Service Bulletin No: 35-001

Modification No: EC-09-0544

**OXYGEN - ON-BOARD OXYGEN-GENERATING SYSTEM (OBOGS)
DO THE MODIFICATION TO THE OBOGS WARNING CONFIGURATION****1. Planning Information****A. Effectivity**

PC-21 aircraft MSN 109 thru MSN 127.

Wiring Diagram (Post Service Bulletin 35-001)
Figure 2

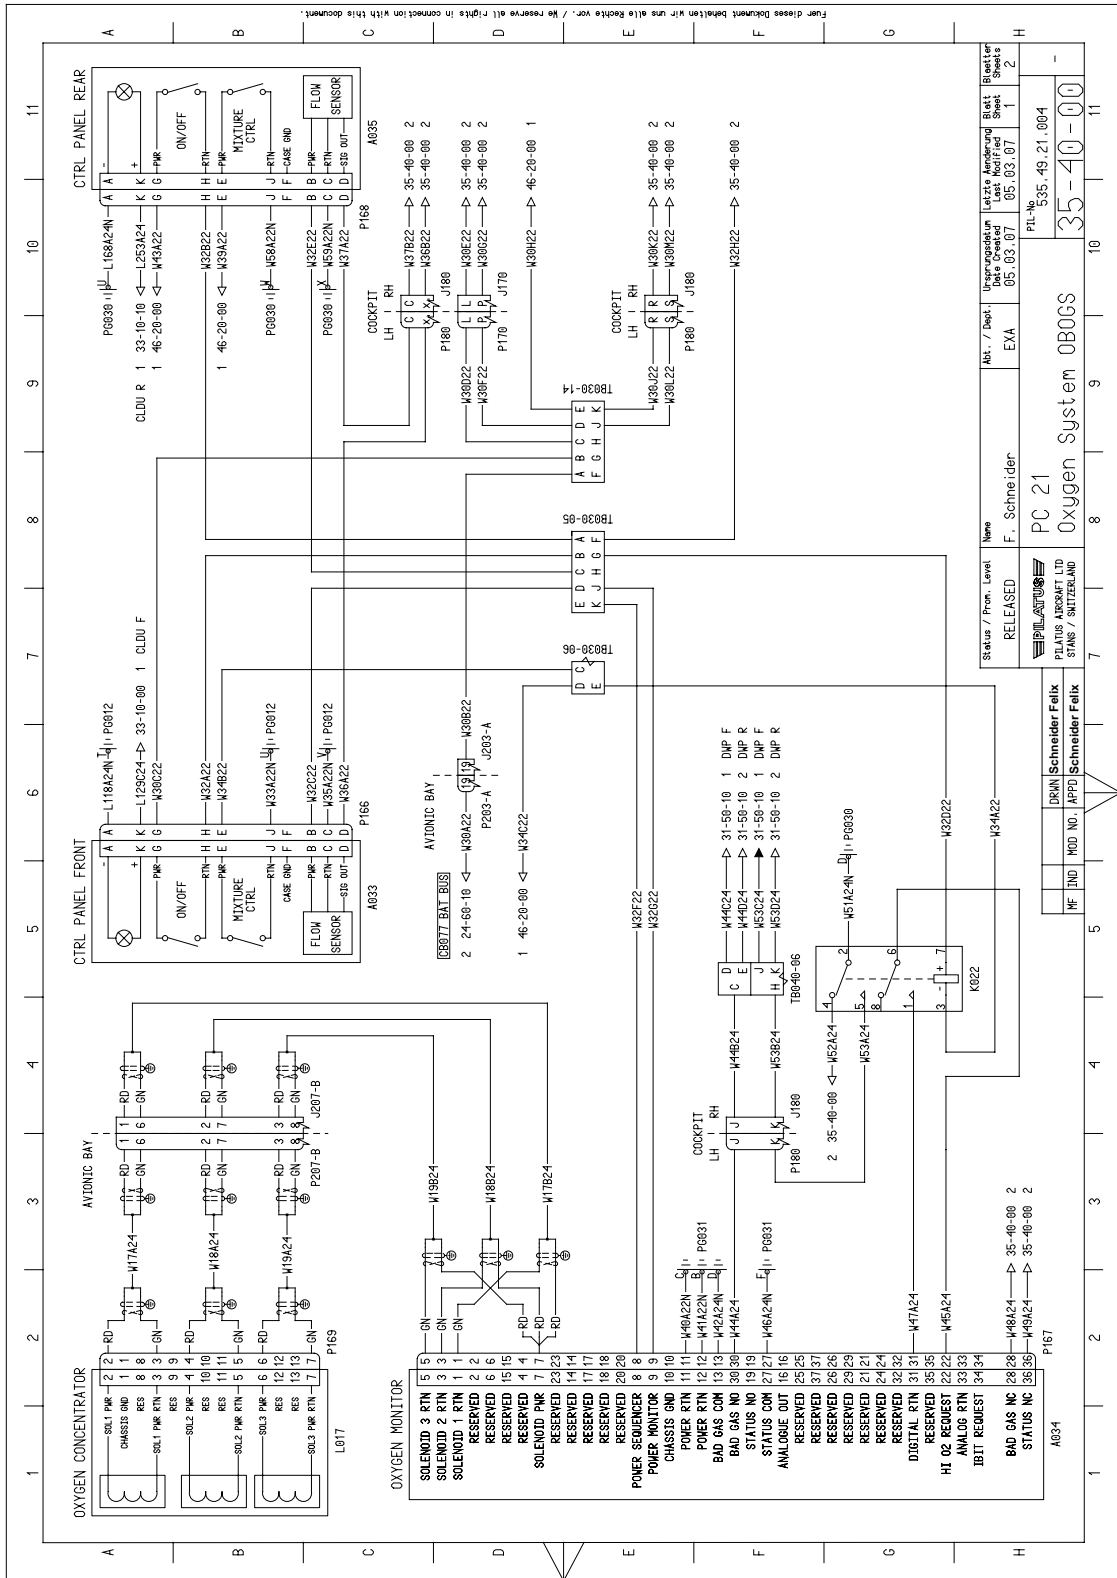
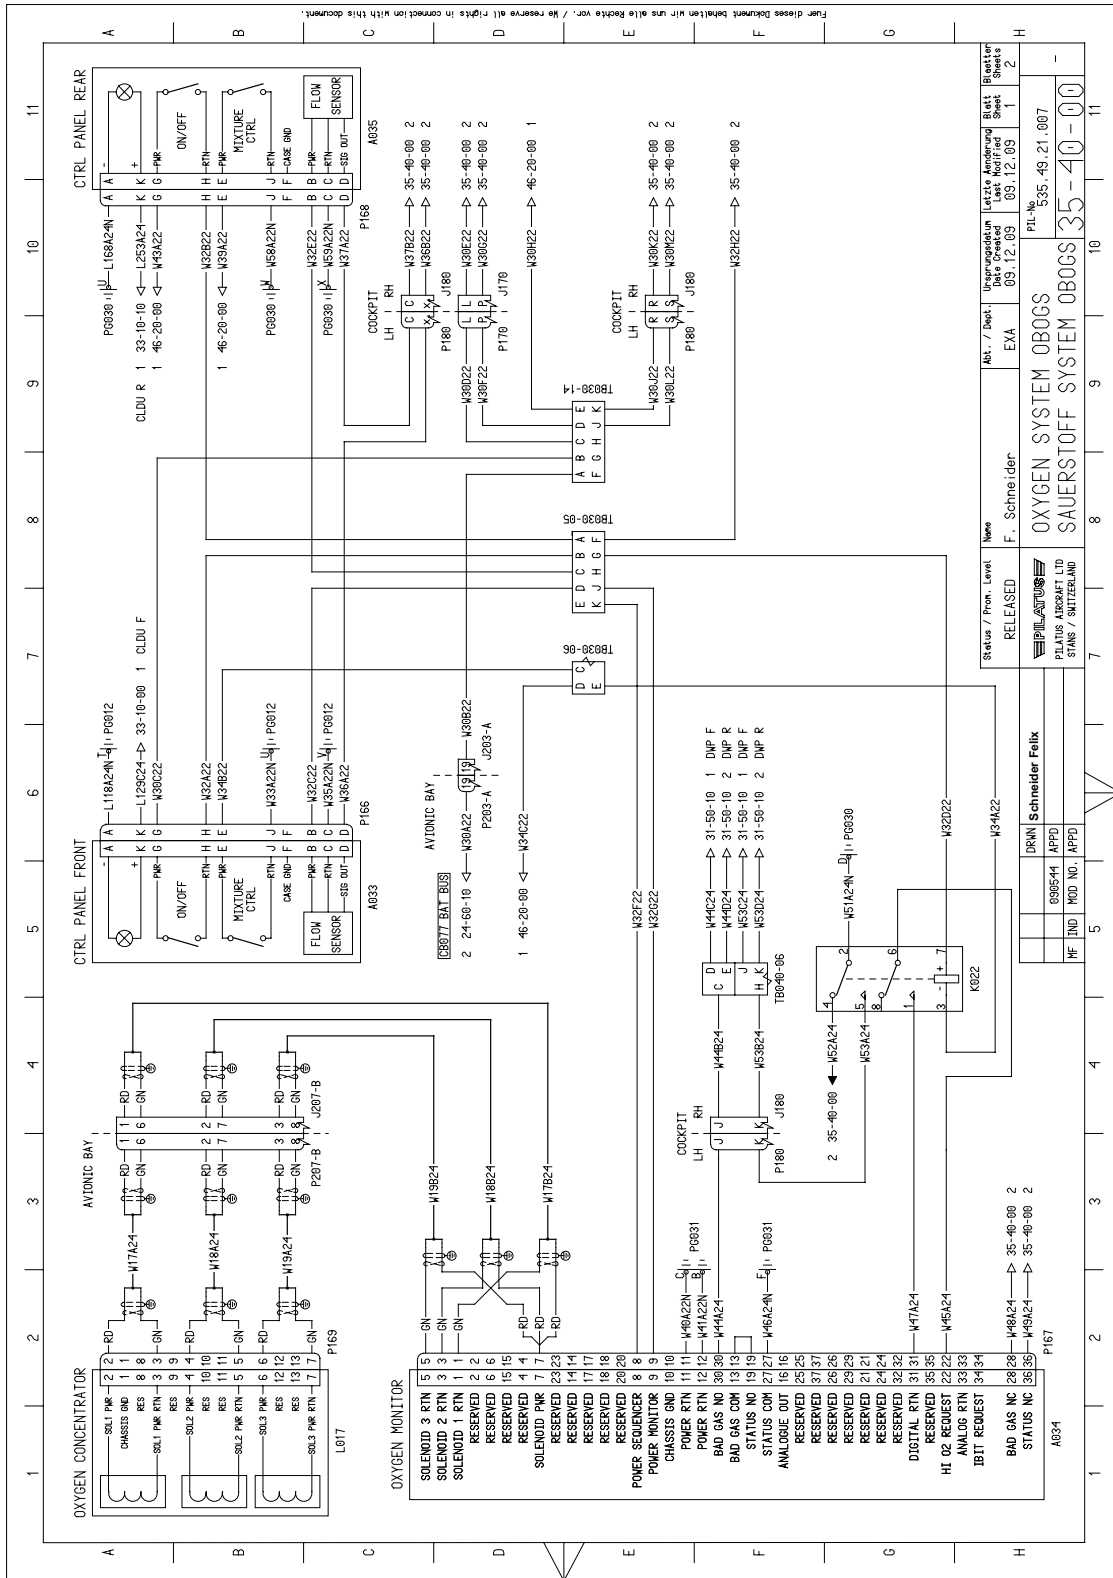
B. Modification (Ref. Figs. 1 thru 3)

- (1) Do the modification to the aircraft wiring:
 - (a) Disconnect and remove the wire W42A24N from between terminal 13 of the electrical connector P167 and terminal D of the electrical ground PG031 located in the rear cockpit on the left side (Ref. Hook-Up Chart, Fig. 3, Line 1).
 - (b) Install the jumper wire (Ref. Hook-Up Chart, Fig. 3, Line 2)
 - 1 Install a pin (P/N 971.75.17.903) on one end of the new wire (P/N 919.79.41.301).
 - 2 Connect the wire to terminal 13 of the electrical connector P167.
 - 3 Route the wire to terminal 19 of the electrical connector P167 and cut to length.
 - 4 Remove the pin from terminal 19 of the electrical connector P167.
 - 5 Install the pin from terminal 19 on the other end of the new wire (P/N 919.79.41.301).
 - 6 Connect the wire to terminal 19 of the electrical connector P167.

Line	End 1			Wire No.	Color	End 2			Remarks
	Ident. No.	Terminal No.	Terminal P/N.			Terminal P/N.	Terminal No.	Ident. No.	
1	P167	13	-	W42A24N	-	-	D	PG031	Disconnect Ends 1 and 2, remove wire
2	P167	13	971.75.17.903	Note 1	-	Note 2	19	P167	New wire. Connect Ends 1 and 2
